## Technical product information

<b>Topic</b>	Gear range selector inoperative
<b>Market area</b>	Worldwide Bentley (1WBE)
<b>Brand</b>	Bentley
<b>Transaction No.</b>	2033480/1
<b>Level</b>	EH
<b>Status</b>	Approval
<b>Release date</b>

Transaction No.: 2033480/1

Gear range selector inoperative

Figure 1

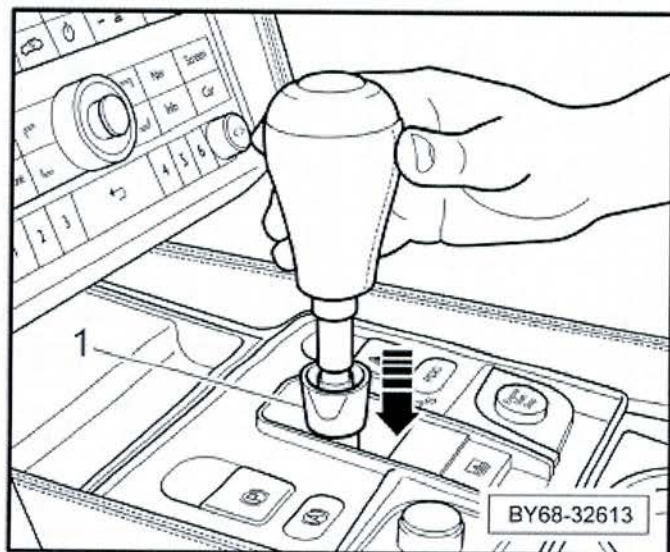
To disconnect/reconnect the gear selector electronics disconnect the 10 way connector (connector

T10ad in current flow diagrams) at the gear selector assembly (see Figure 1)

Figure 2

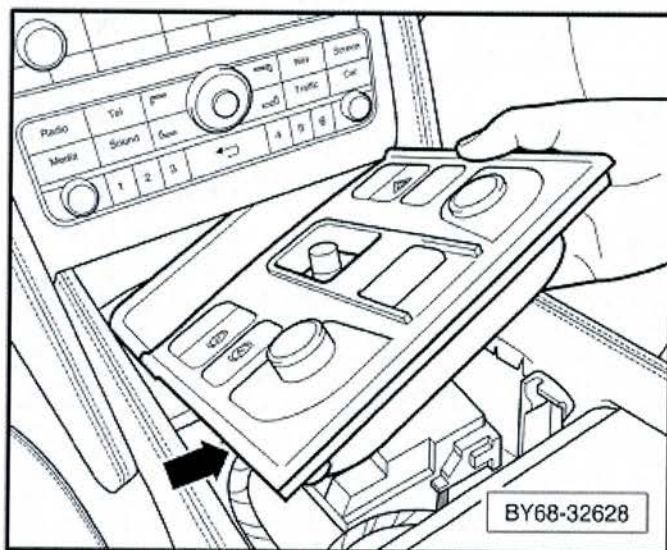
1. Slide the collar -1- downwards then pull off the gear selector knob
